**Nightsun<sup>®</sup> XP Searchlight**  
**Safety and Service Bulletin # SL 0810-01**

Amendment # 3

**Subject: Gimbal Azimuth Top Hex Nut**

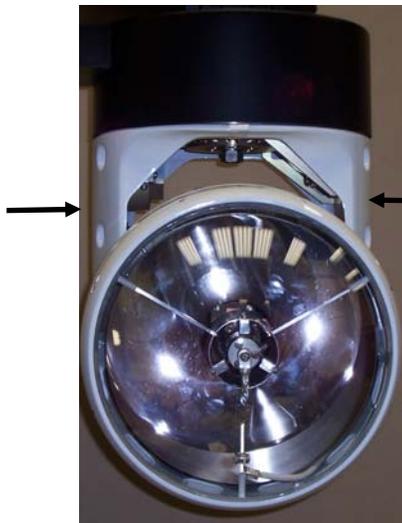
Under certain conditions, the Gimbal's Azimuth Top Hex-Nut may become loose. The Gimbal's Azimuth Top Hex-Nut is located internal to the Gimbal under the top Shroud Cover in the dovetail mount location. A loose nut could cause; a gap between rubber edging of the top Shroud and the Gimbal frame; degradation of pointing accuracy and stability performance; and pose excessive vibration on the aircraft. If the nut were to entirely disengage, the Searchlight/Gimbal could potentially disconnect from the aircraft and remain attached solely by the internal cable harness.

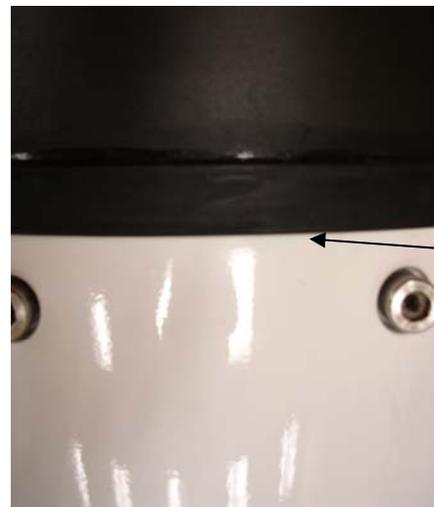
1. Ensure the Searchlight/Gimbal is vertically mounted to a fixed location.
2. Visually inspect the Gimbal for a gap between the Top Shroud rubber edging (P/N 033381) and the Side Covers (P/N 033286). When the Gimbal's Azimuth Top Hex-Nut is properly fastened, the edging should be in physical contact with the Side Covers.
3. Try to move the Searchlight laterally (reference figure below). No gap should appear between the Top Shroud rubber edging (P/N 033381) and the Side Covers (P/N 033286) and no play should be felt.
4. If a discrepancy is encountered, remove the system from the aircraft and contact Spectrolab (below) for retrofit options to comply with the Corrective Action section of this bulletin.
5. If a discrepancy is not encountered, please contact Spectrolab (below) for retrofit options to comply with the Corrective Action section of this bulletin.

Gap should not appear when pressure is applied on the Side Covers when trying to create side-to-side motion from either side.

Rubber edging should be making contact with Side Cover and a gap should not be present here
